**TO:** Peter Domine, Planner II  
Community Planning and Development Department

**FROM:** Laurel Christian, Infrastructure Planner III  
Community Planning and Development Department

**SUBJECT:** **Infrastructure Memo**  
**SPR-ADJ-DAP-DR24-27 (24-103565-PLN)**  
**676 17<sup>th</sup> Street SE**  
**12-unit Multi-family Development**

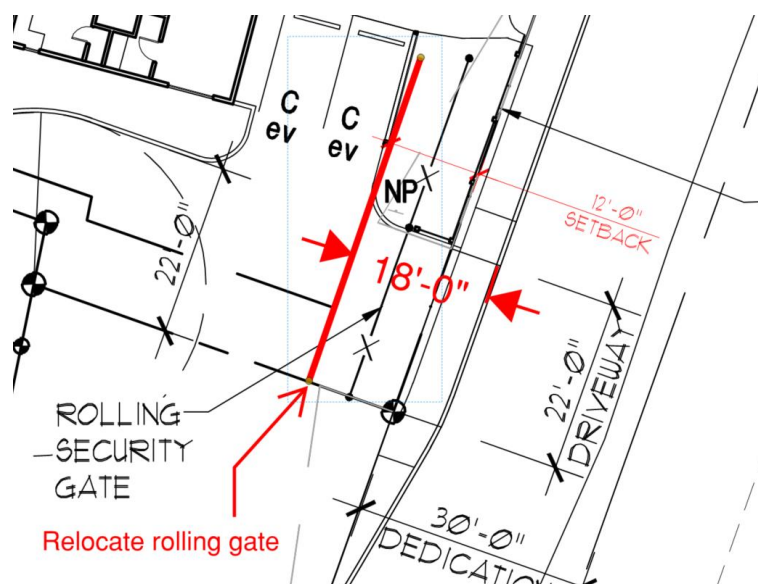
**Finding:** The applicants site plan shows a rolling gate at the driveway approach onto Oak Street SE. The gate is set back 12-feet from the property line, which does not provide adequate space for a vehicle to wait for the gate to open without blocking

vehicular traffic on Oak Street SE. The Assistant City Traffic Engineer has reviewed the site plan and found that the proposal, including the gate, would not provide for safe and efficient movement of vehicles in and out of the development site as it would interfere with vehicle movements within the street. The Assistant City Traffic Engineer requires the gate be to a minimum of 18-feet back from the curb along Oak Street SE, which will allow for one vehicle to queue and wait for the gate to open without blocking vehicle movements within the street. As shown on the image below, the gate will be approximately 18-feet from the curb and align with approximately at the edge of the first parking space upon entering the site.

**Condition:** The gate for the driveway approach onto Oak Street SE shall be setback approximately 18-feet from the back of the curb of Oak Street SE or the plans shall be revised to eliminate the gate.
